APPEAL SUMMARY

Appeal ID: 15953	Project Address: 5 SE MLK Jr Blvd
Hearing Date: 10/11/17	Appellant Name: Joe Dietz
Case No.: B-016	Appellant Phone: 312-768-6236
Appeal Type: Building	Plans Examiner/Inspector: Jerry Englehardt
Project Type: commercial	Stories: 17 Occupancy: R-2, B, S-2, M, A-2 Construction Type: 1-A
Building/Business Name: 5 MLK	Fire Sprinklers: Yes - Throughout
Appeal Involves: Erection of a new structure	LUR or Permit Application No.:
Plan Submitted Option: pdf [File 1] [File 2]	Proposed use: Residential, Office, Retail and Parking

5 MLK

LEVEL 17 PLAN

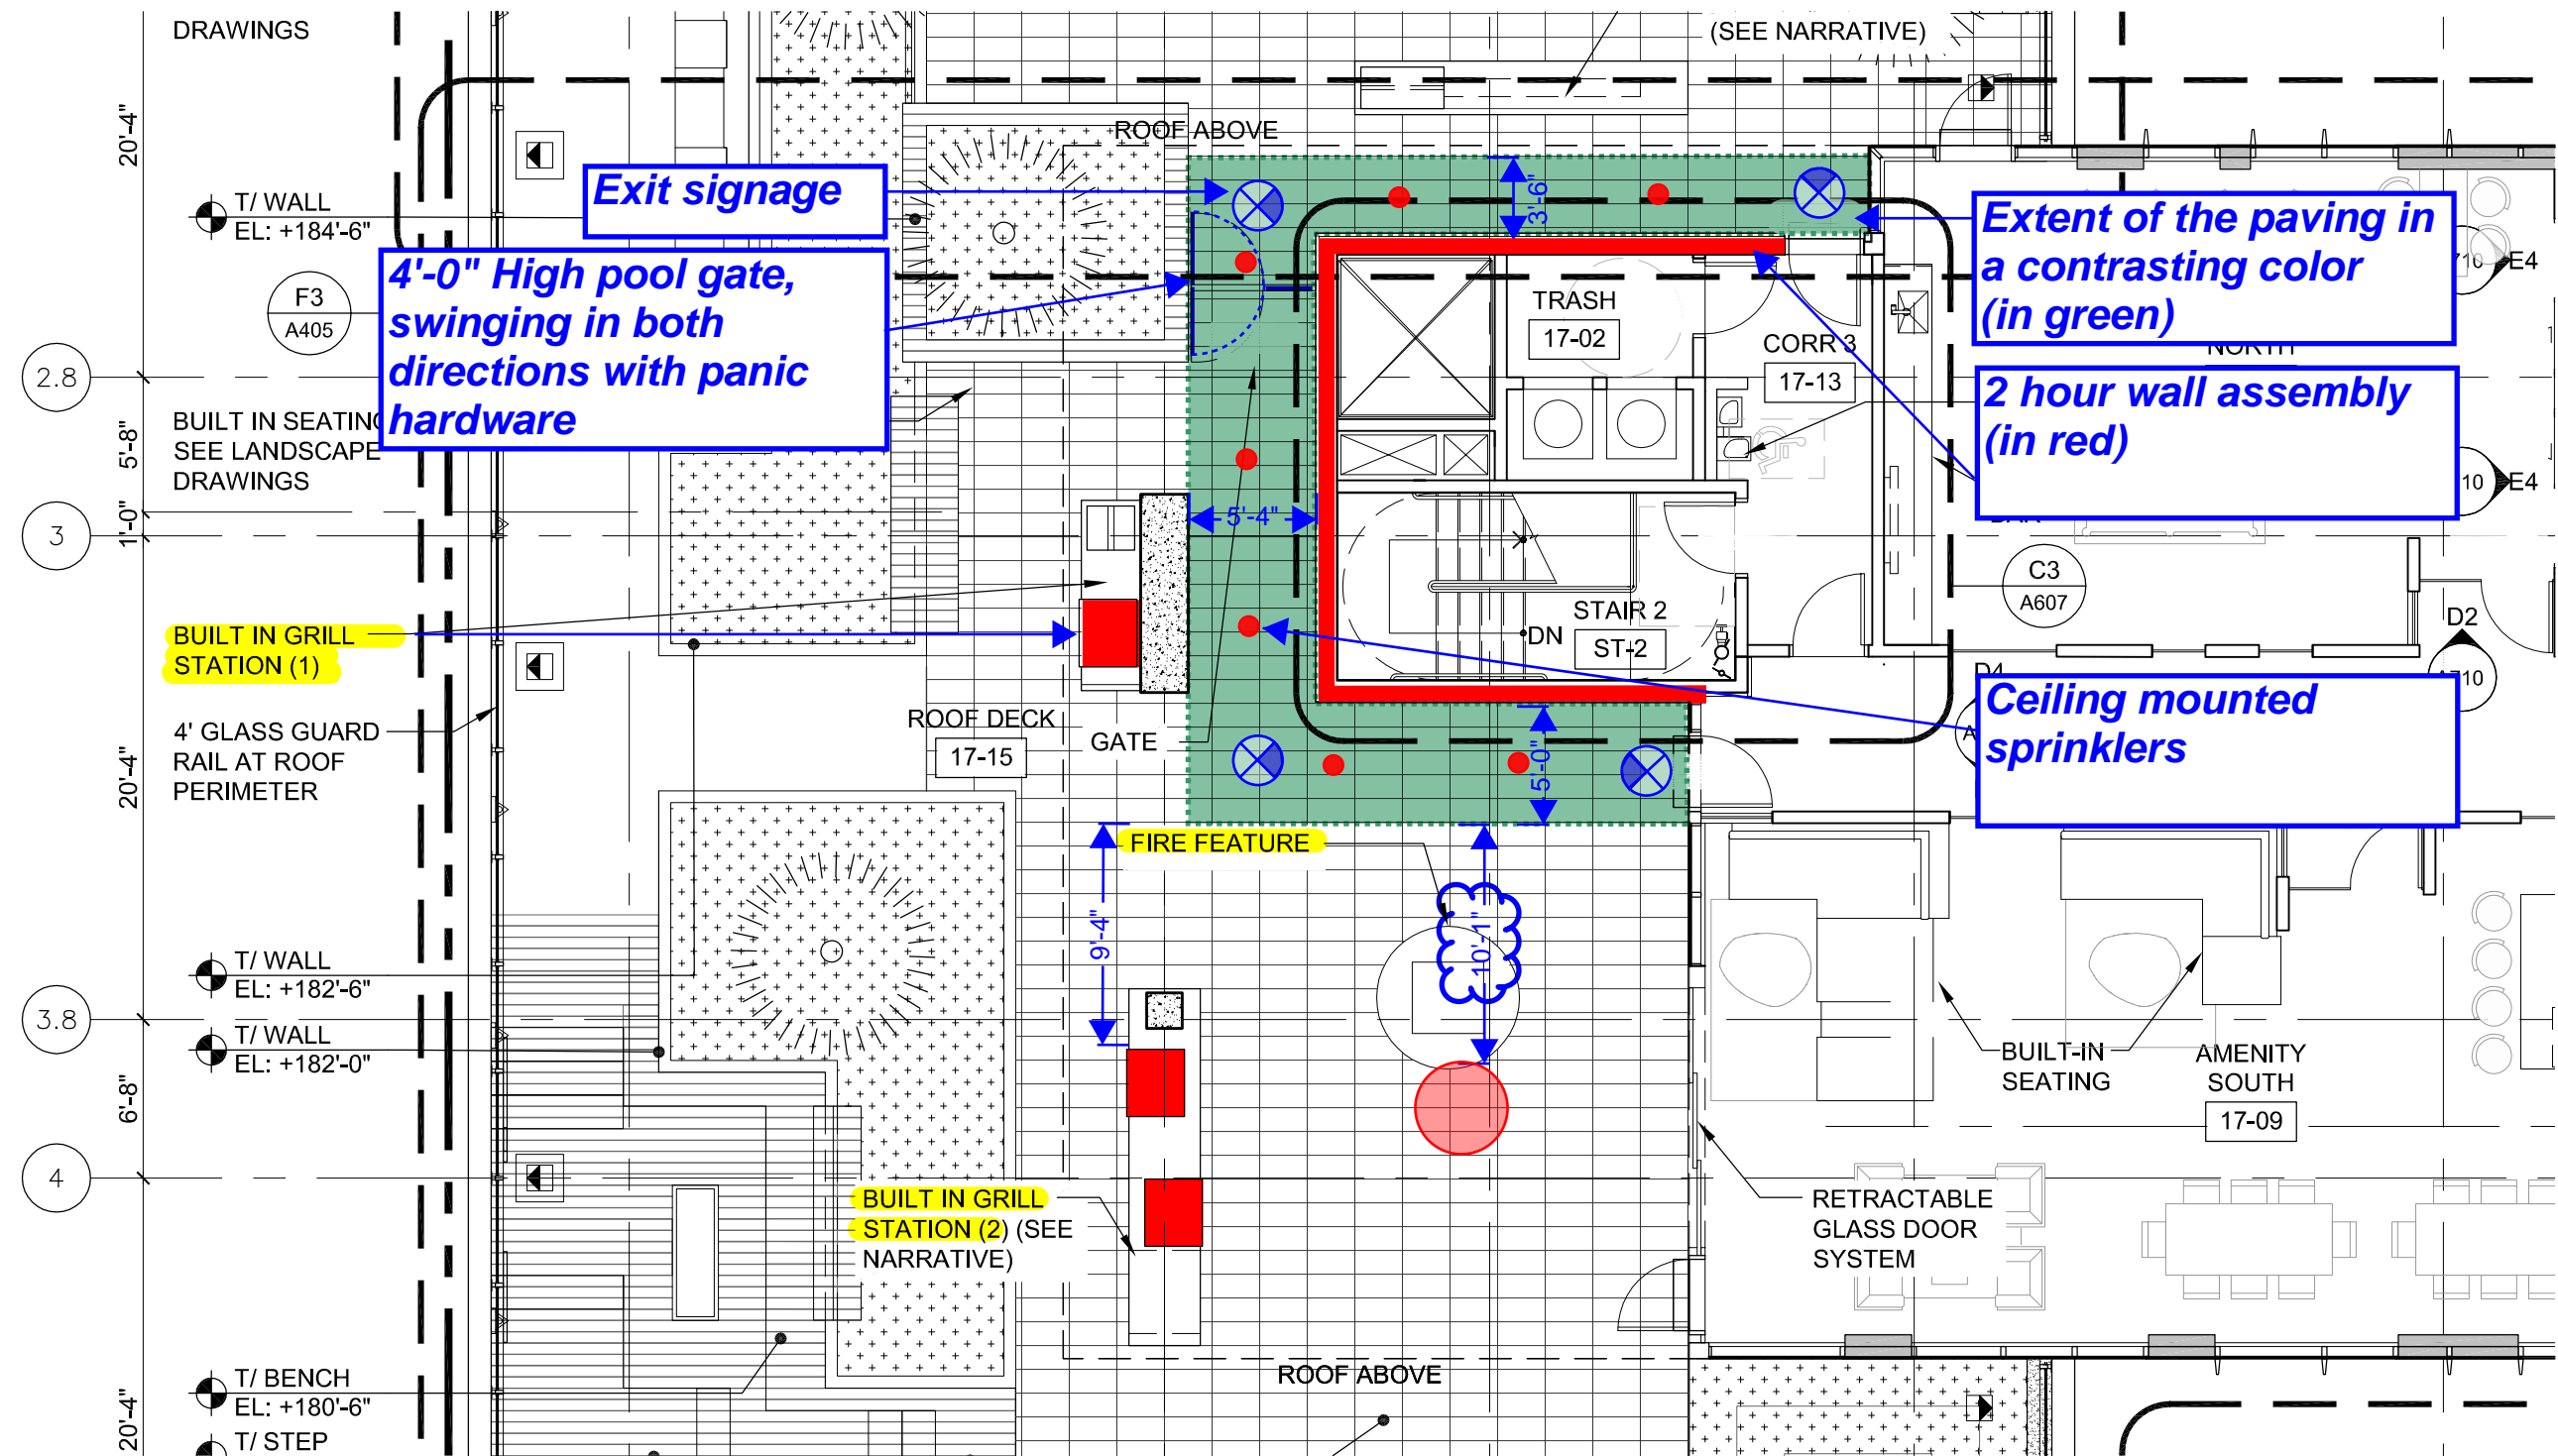
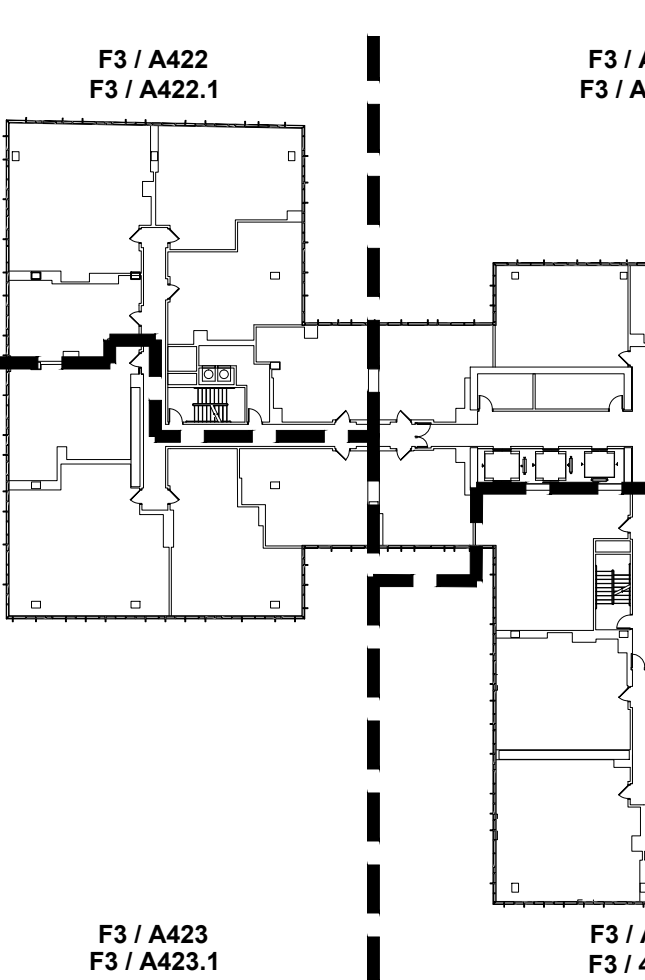
Proposed Design The proposed design is to have an amenity roof deck on the 17th floor that will serve the residential occupants on the outdoors deck area of the fully sprinkled building. The two doors egress from the outdoor deck area meets the requirements of OSSC 1015.2.1, exception 2, in combination with the commentary provision for the exits being measured along the path of travel when the two exits are connected by a 1 hour corridor. In order to protect the occupants egressing the outdoor deck to the 2 egress points on the roof, we are proposing a route that will meet the requirements of the connected 1 hour corridor provision and exceed the requirements of a protected egress balcony. To meet these requirements and protect the occupants accessing the egress points we will provide the following additional protection measures:

Reason for alternative The diagonal distance of the occupied portion of the roof deck is 120'-0", the diagonal distance between the exits are 23'-6". We are proposing using the provision in the commentary for OSSC 1015.2.1 for remoteness of exit being calculated along the path of travel in a 1 hour rated corridor by providing an exterior egress balcony and other systems as noted above along the path of travel between the points of exit to allow the actual path of travel measurement (65'-6") between the

The egress doors on the 17th floor roof deck meet the requirements for separation along the path of travel in a 1 hour rated corridor by exceeding the protection of a 1 hour rated corridor by providing a protected and separated exterior egress balcony, therefore providing equivalent protection for the two means of egress from the roof deck area.

3. Separation of exit access doorways: Granted provided additional exit signage and luminous markings along the path of exterior egress is provided.
